P 35248
A REPAIR

SEWAGE DISPOSAL SYSTEM
MARYLAND STATE DEPARTMENT OF HEALTH

SUBDIVISION Poplar Springs ROAD 912 Watersville Road LOT 69 PCL

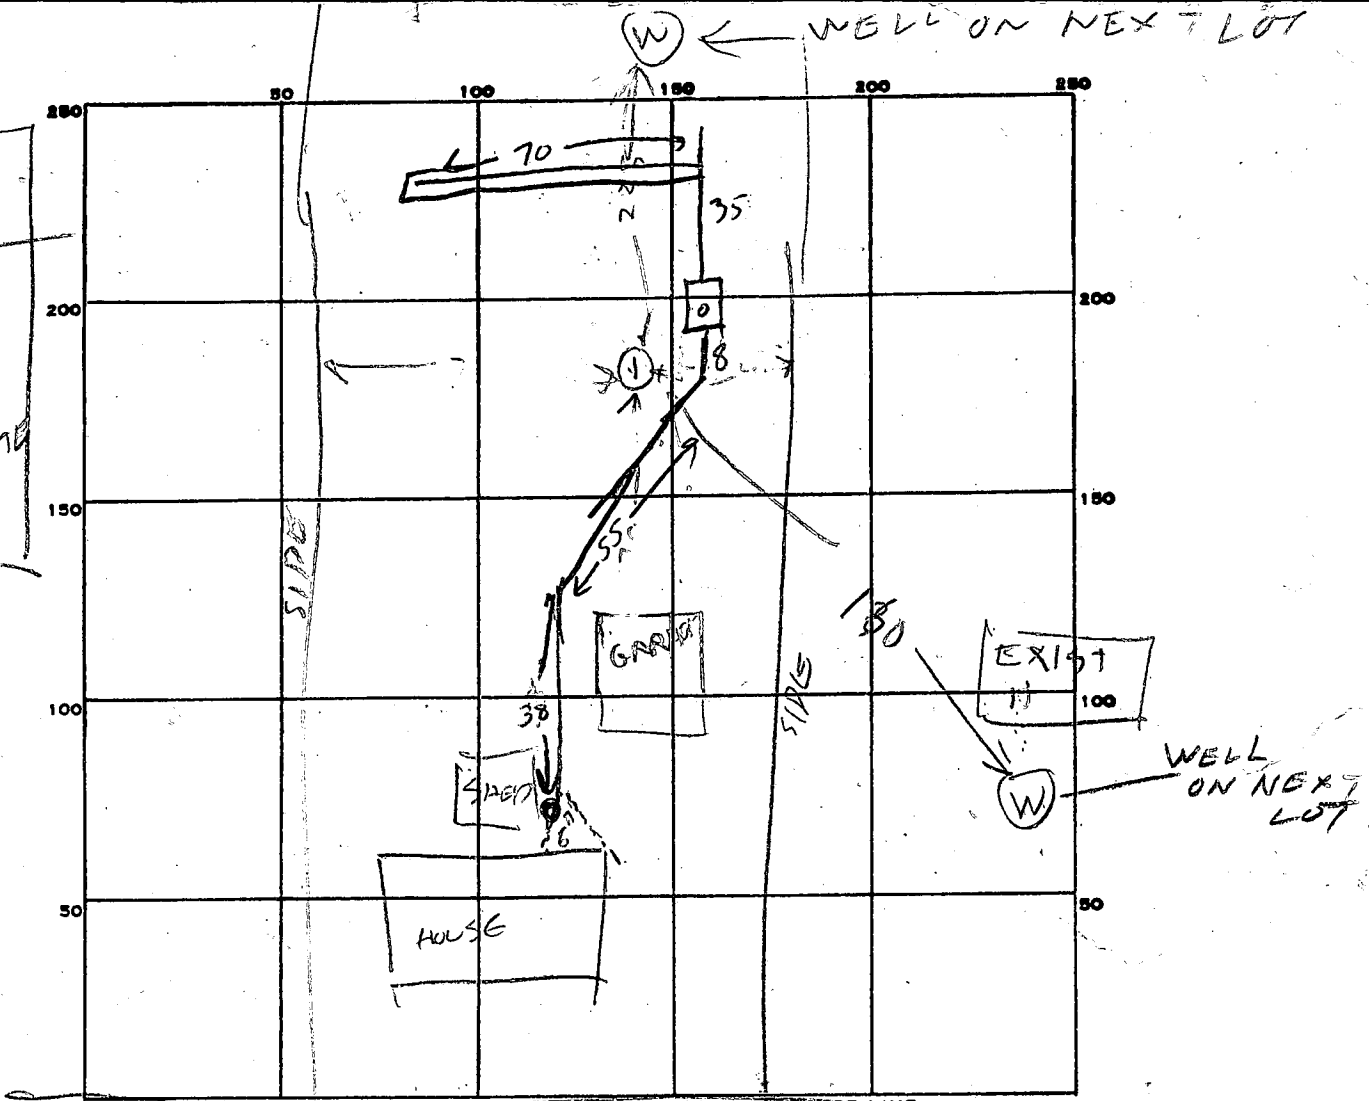
REMARKS	4/16/85	15	8	114	117	117	1126	9
		1V	12	LOOKS OK Below 3 1/2 FT

SOIL OK BUT NOT SURE OF WELL SITE
 BOB ARNOLD TO MARK WELL SITE RH
 EXISTING DRY WELL ABANDONED & FILLED CW ✓

14/18/85 TWO LINES FROM HOUSE CONNECTED TO ONE NEW LINE TO TANK,
 TRENCH OK TO COVER CW
